Access Compliance Report

Public Rights-of-Way

(Curb Ramps)

Intersection ID: 10024552	Main Street: D_DUCKS_LN	Cross Street: N/A	Location: N
ADA ID: E70079F09AF9	Ramp Type: BlendTrans1	Initial Pass/Fail: Fail	Overall Compliance: No
			Severity Score: 33.75

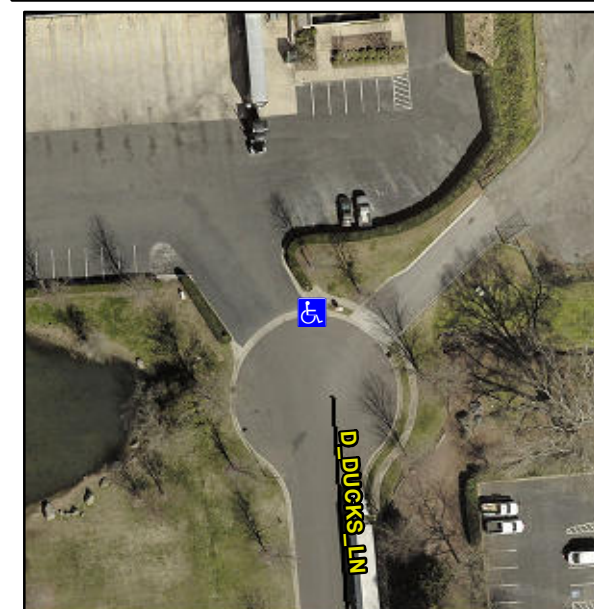
R304.5.1, R304.5.3

Compliance	Description	Data	Compliance	Description	Data
N/A	Ramp Length (in)	47.0	Yes	BlendTrans Slope (%)	4.4
No	Ramp Width (in)	41.0	No	BlendTrans XSlope (%)	7.2
N/A	Flare Type LT	N/A	N/A	Flare Type RT	N/A
N/A	Flare Slope LT (%)	N/A	N/A	Flare Slope RT (%)	N/A
N/A	Flare Traversable LT?	N/A	N/A	Flare Traversable RT?	N/A
N/A	Landing Length (in)	N/A	N/A	DWS Provided?	N/A
N/A	Landing Width (in)	N/A	N/A	DWS Contrast?	N/A
N/A	Landing Slope (%)	N/A	N/A	DWS Length (in)	N/A
N/A	Landing X Slope (%)	N/A	N/A	DWS Full Width?	N/A
N/A	Landing Curb? (Y/N)	N/A	N/A	DWS Offset (in)	N/A
N/A	Shared Landing?	N/A			
N/A	Gutter Ponding?	N/A	N/A	Gutter Slope (%)	N/A
N/A	Gutter Lip Ht (in)	N/A	N/A	Gutter X Slope (%)	N/A
N/A	Painted X Walk1?	No	N/A	Painted X Walk2?	N/A
	X Walk 1 Direction	To SW		X Walk 2 Direction	N/A
	X Walk 1 Width (in)	N/A		X Walk 2 Width (in)	N/A
	X Walk 1 Slope (%)	0.4		X Walk 2 Slope (%)	N/A
	X Walk 1 X Slope (%)	4.1		X Walk 2 X Slope (%)	N/A

Remove & Replace Curb Ramp With Two New Directional Ramps or Equivalent.
